Coronado
> Business Class M2
Cascadia
108SD/114SD

Freightliner Service Bulletin

Description of Revisions: *This bulletin replaces the version dated July 2013. Incompatibility of the service kit with transmission-mounted PTOs has been noted.*

Fig. 1, Existing Shift Cable Installation

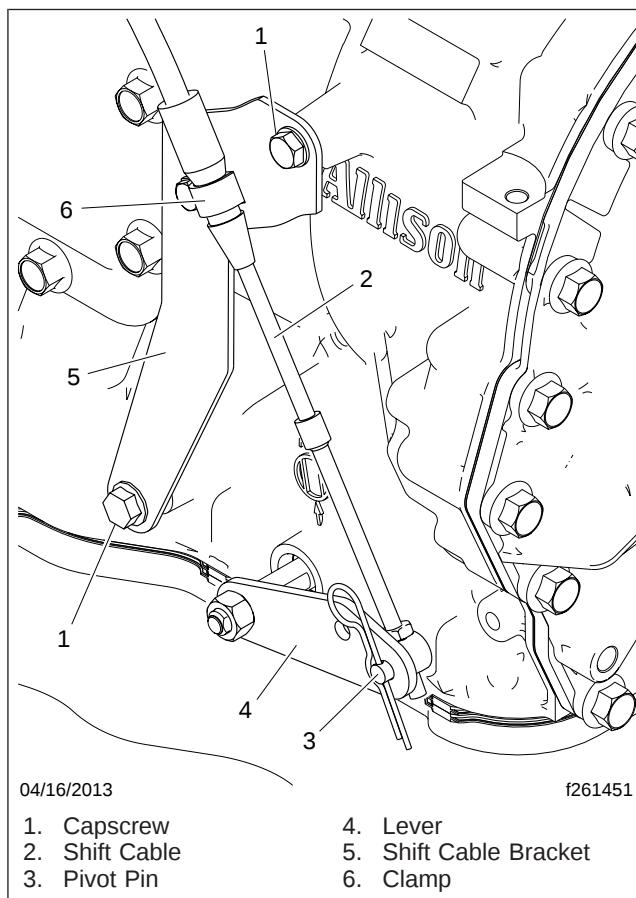
Some M2 vehicles with Allison 6-speed transmissions may produce a buzzing or chirping noise emanating from the shift lever. This usually happens when the transmission is in 6th gear, and the vehicle is moving at 50 to 55 mph (80 to 89 kph). Shifting out of 6th gear stops the noise. A shift cable isolator kit has been developed to eliminate the cause of the noise. If a noise is emanating from the shift lever or shift cable, use the procedure in this bulletin to replace the existing shift cable clamp (see [Fig. 1](#)) on the transmission with the isolator kit KPP 294201.

1. Park the vehicle on a level surface, set the transmission in NEUTRAL, shut down the engine, and set the parking brake. Chock the tires.
2. Remove the cotter pin, then remove the pivot pin and shift cable from the transmission shift lever. See [Fig.1](#).
3. Remove the pivot pin from the shift cable.
4. Remove the clamp that secures the shift cable to the cable bracket. Save the bolt and discard the clamp.
5. Remove the two capscrews that attach the cable bracket to the transmission, then remove the bracket.
6. Using the isolator kit mounting bracket ([Fig. 2](#), item 4) as a template, with one hole positioned over the existing hole in the cable bracket, mark and drill a 1/4-inch (7-mm) hole in the cable bracket, as shown in [Fig. 3](#).

Fig. 4, Isolator Bracket Installation

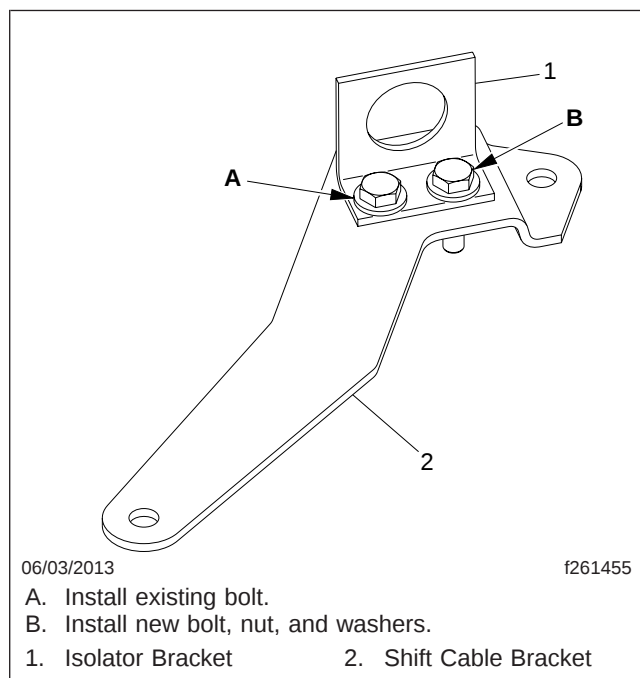
7. Enlarge the existing holes in the isolator kit mounting bracket to fit the fasteners.
8. Install the new bracket on the shift cable bracket, using the existing capscrew and the new bolt, nut, and washers. See [Fig. 4](#). Tighten the existing capscrew 35 lbf-in (395 N·cm), and the new bolt 60 to 84 lbf-in (680 to 950 N·cm).
9. Install the cable in the bracket using the remaining isolator kit parts. Make sure the snap ring is seated in the groove of the plastic bushing; see [Fig. 5](#).
10. Install the pivot pin on the shift cable.
11. Install the cable bracket on the transmission. Tighten the capscrews 18 to 21 lbf·ft (24 to 28 N·m).

Fig. 6, Isolator Kit Installed

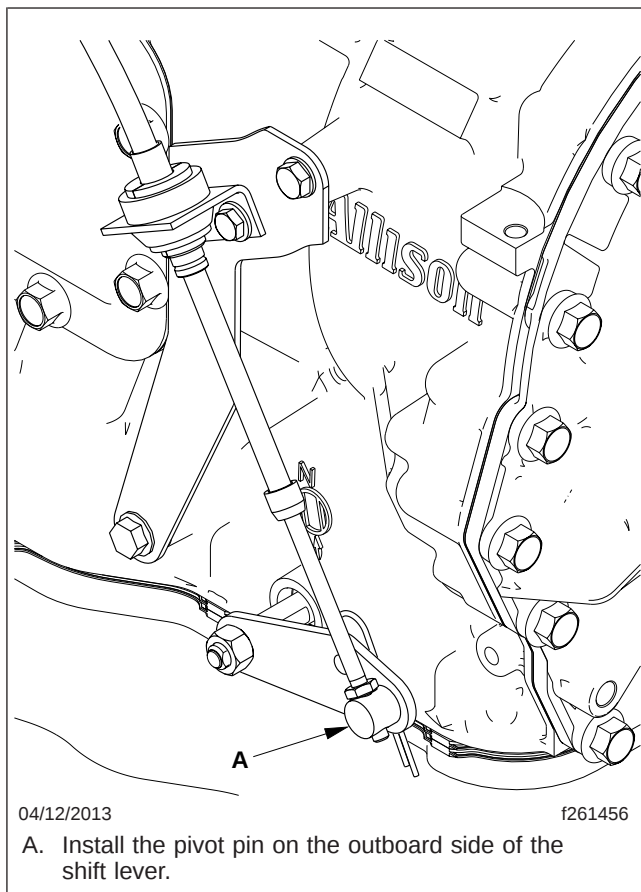
12. Install the pivot pin on the outboard side of the shift lever, as shown in [Fig. 6](#).
13. Make sure the shift control on the dash is set to "Neutral", and the shift lever on the transmission is in the "Neutral" position, as determined by the orientation of the shift lever shaft and the neutral position indicator. See [Fig. 7](#).
14. Adjust the position of the pivot pin along the cable rod so it is lined up with the hole in the shift lever. The pin should slide freely in the shift lever hole when the pin is aligned correctly.
15. Tighten the jam nut snugly against the pivot pin.
16. Install the cotter pin on the pivot.
17. Make sure that there is clearance between the shift cable and the fuel lines.
